SR 25 CO/West Bay Street From I-516 to the Bay Street Viaduct

NHS00-0002-00(923), P.I. No. 0002923
Chatham County, Georgia

Value Engineering Study Report

September 2009

77

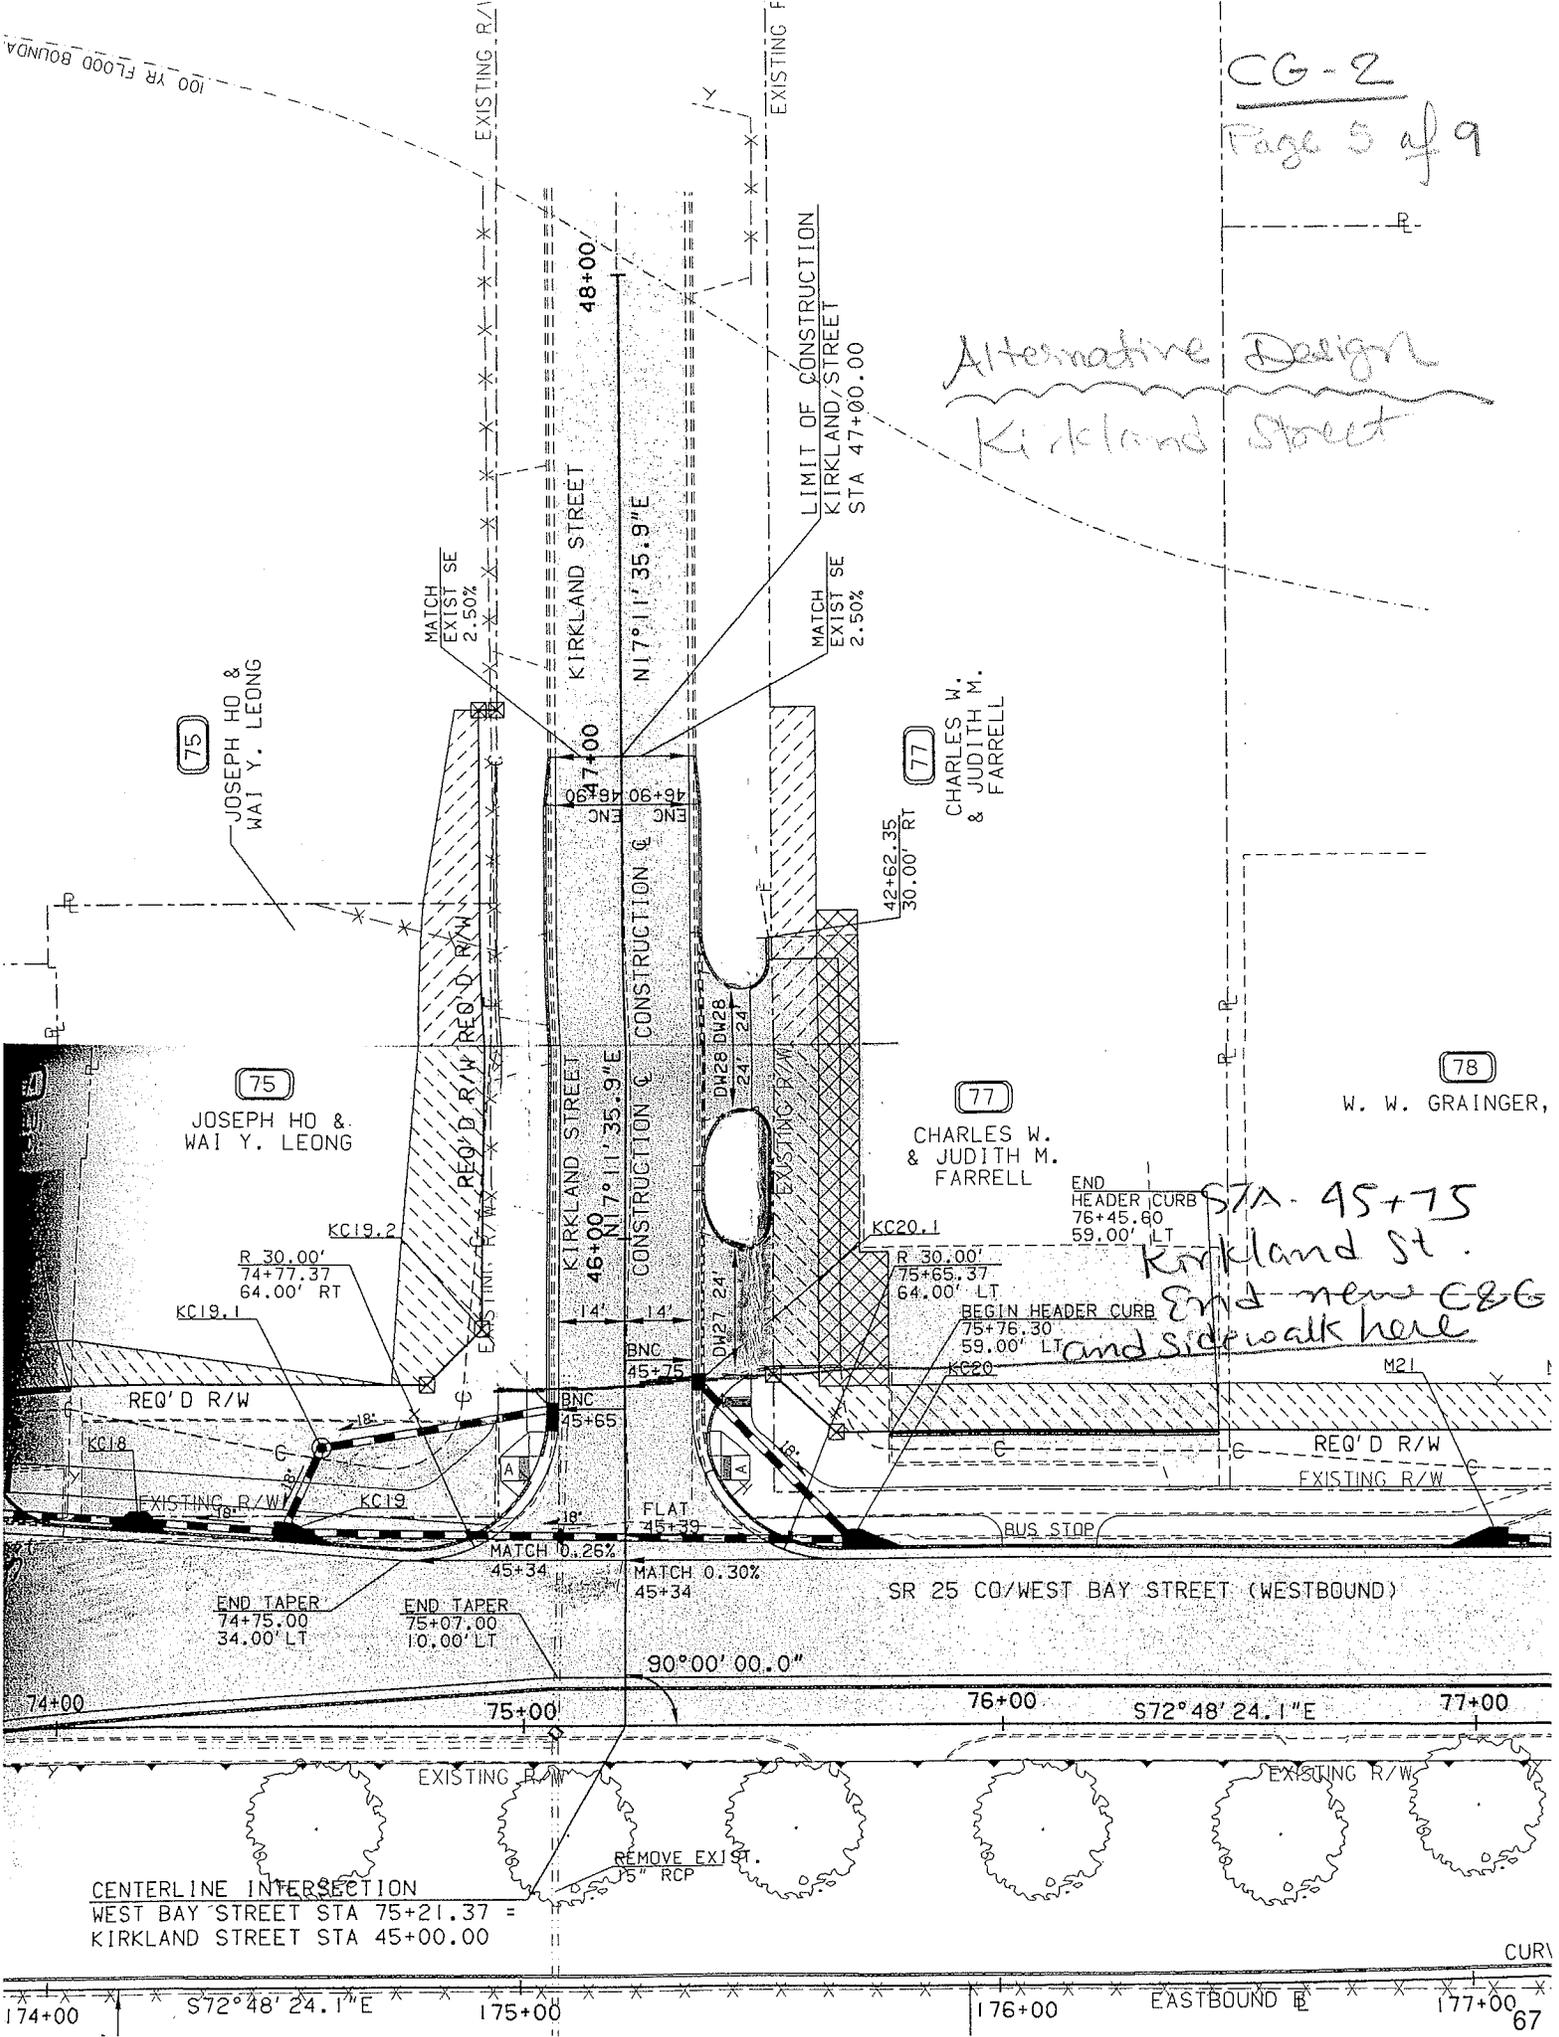
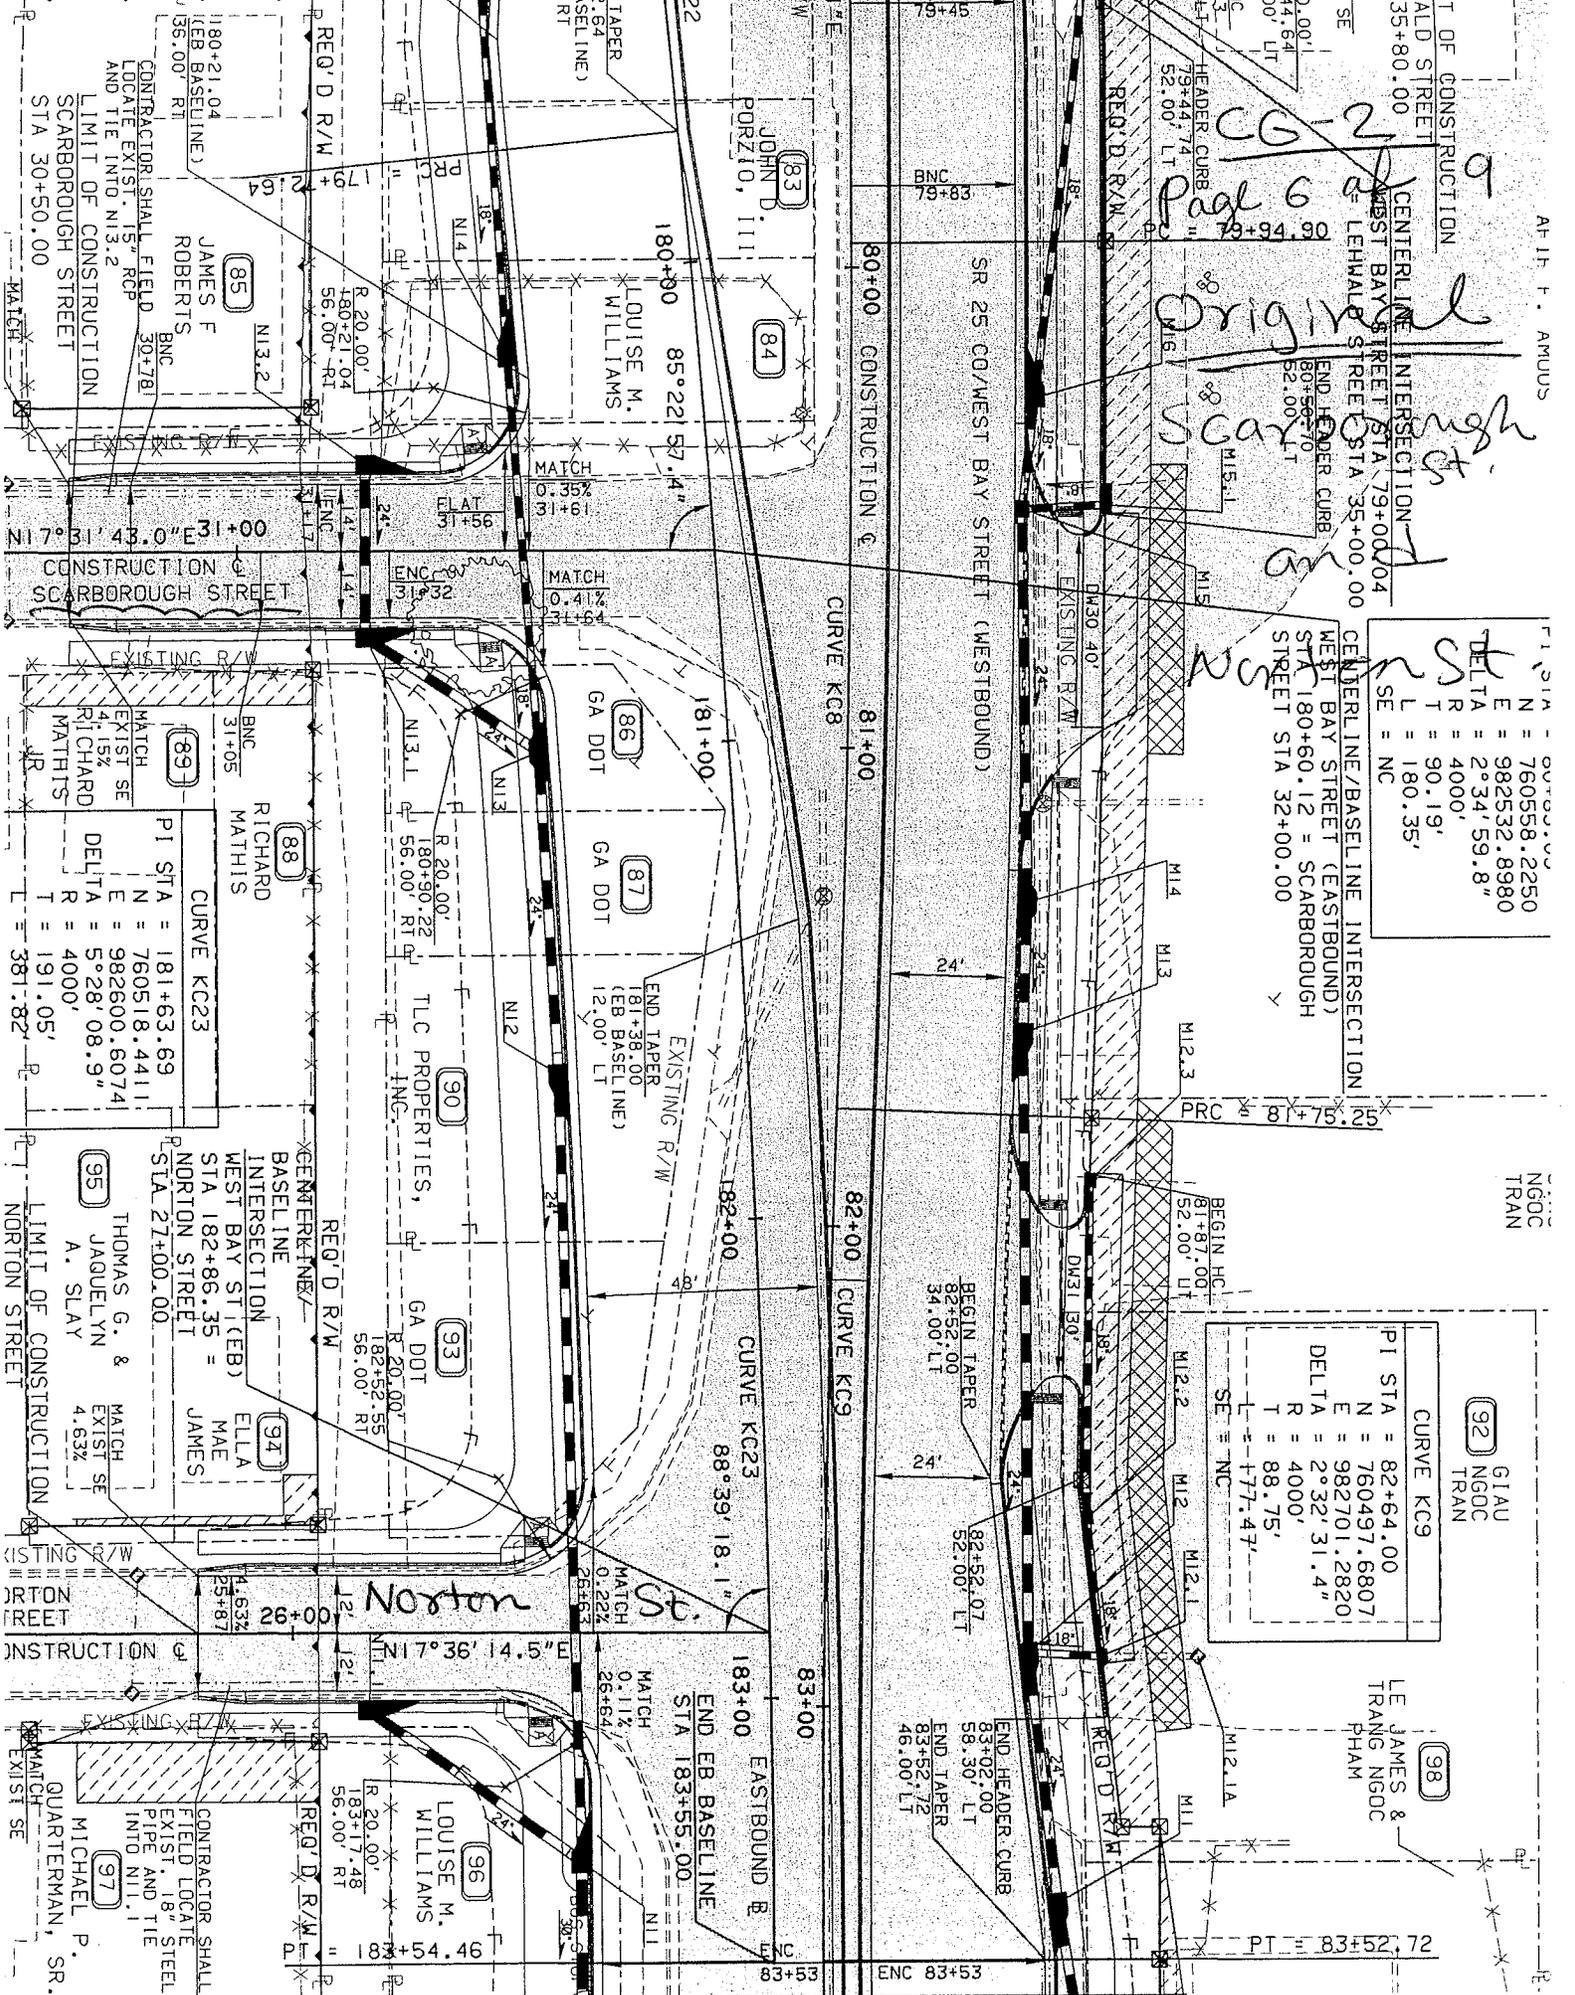
There is no appreciable advantage in removing existing curb and gutter and putting new ones along with 6-ft-wide sidewalks on the side roads. Considerable time and money can be saved by eliminating them.

ALT. NO.
W-1
Sht. 2 of 8

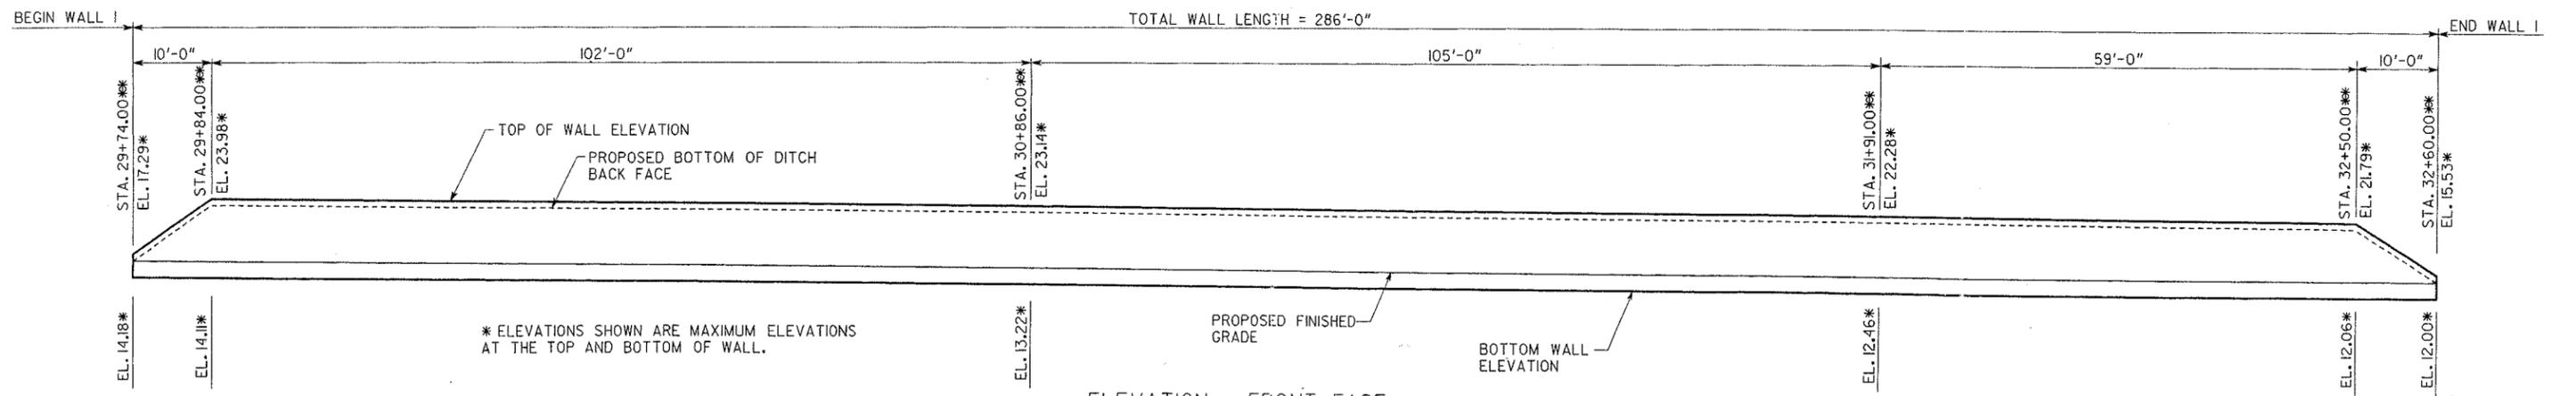
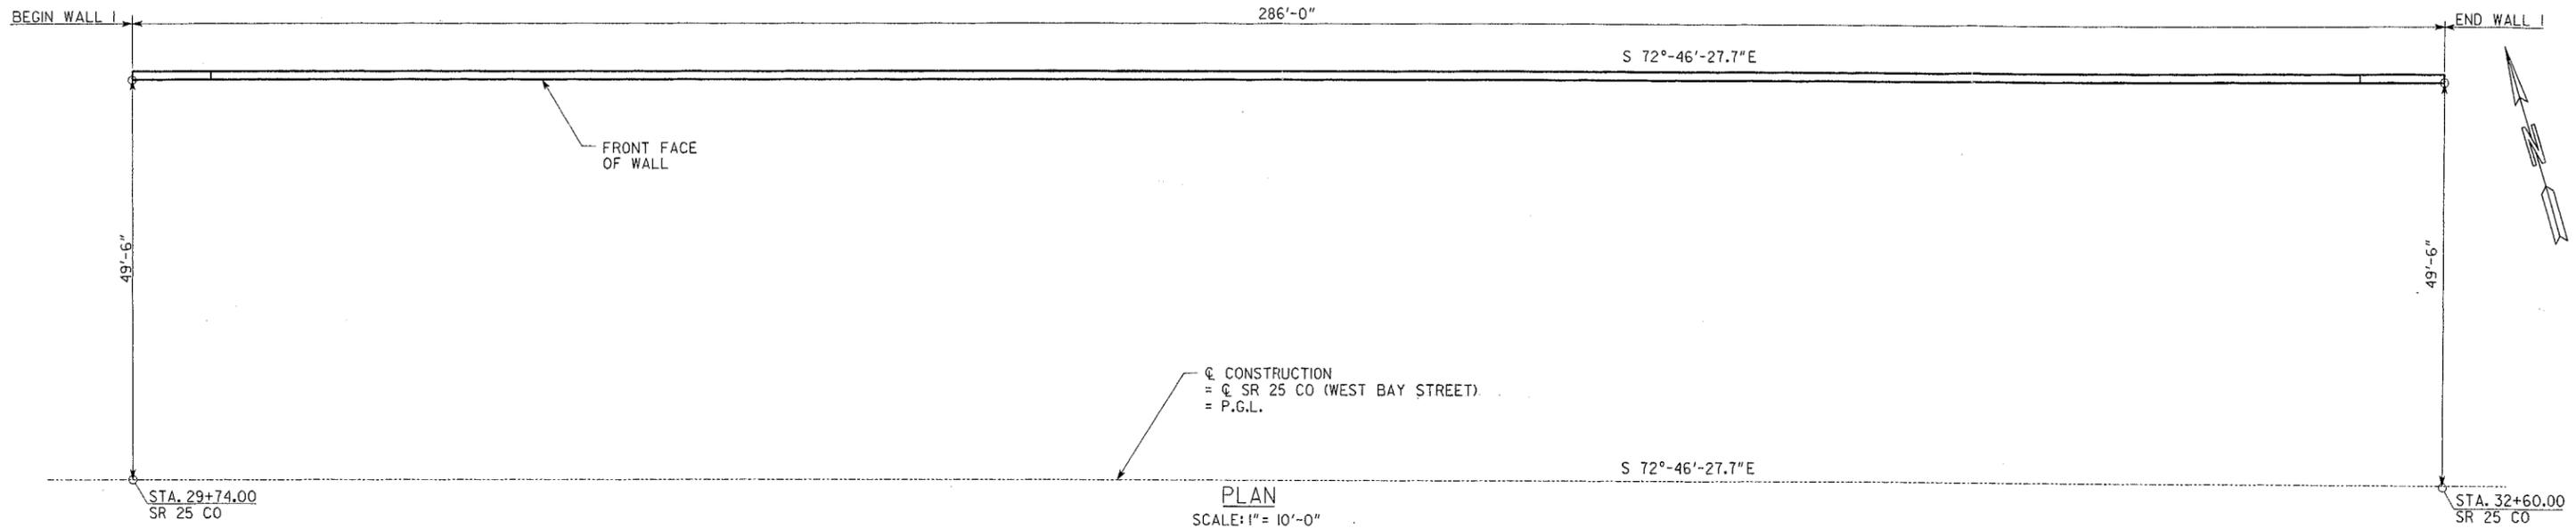
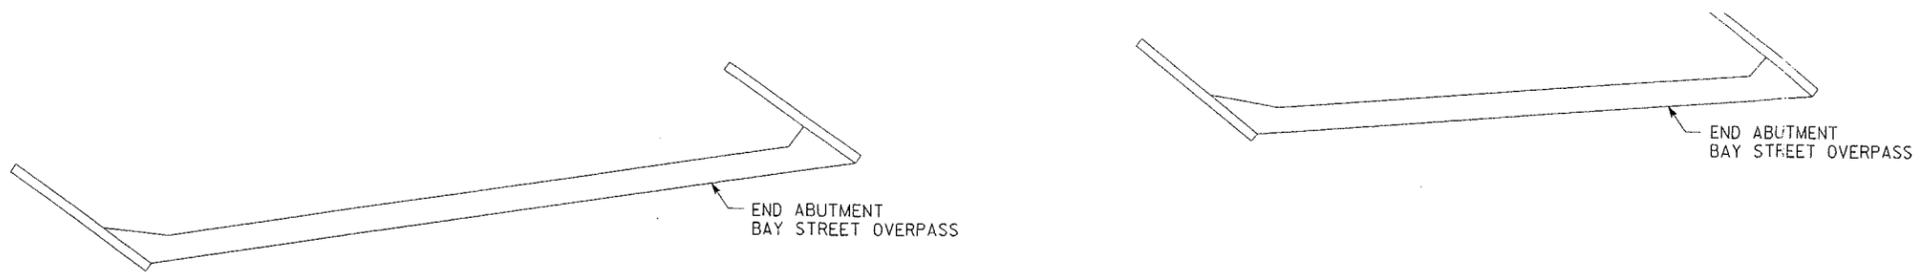
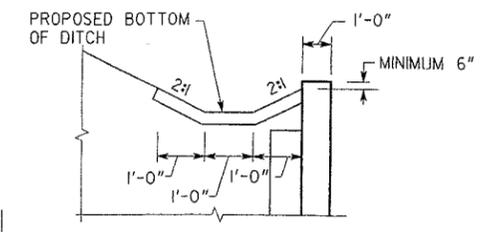
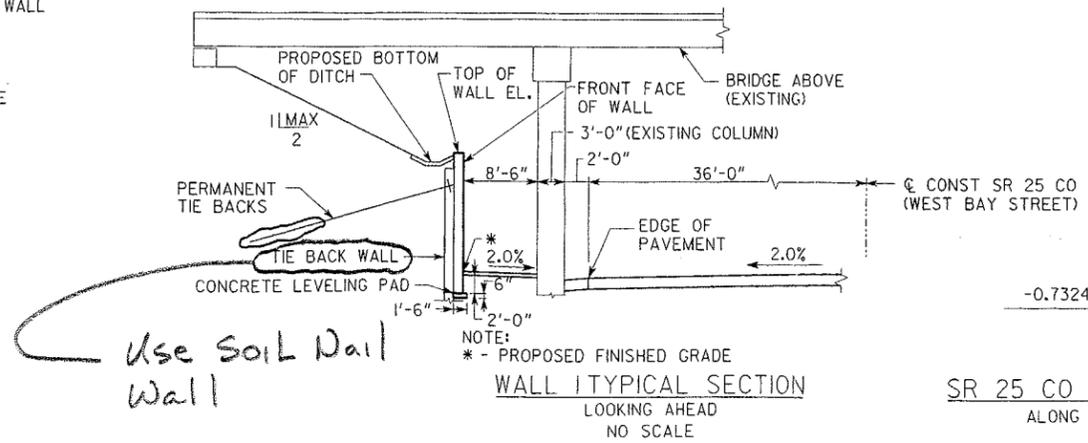
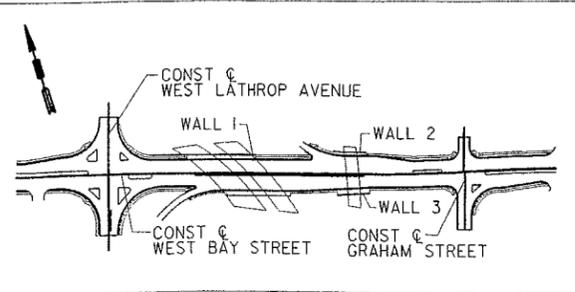
Substituting a soil nail wall for the tie-back wall will reduce the time required to construct the wall due to not having to come back and tension the soil nails as well as allowing the grouting to be performed in one step. The time savings results in an overall cost saving for the project.
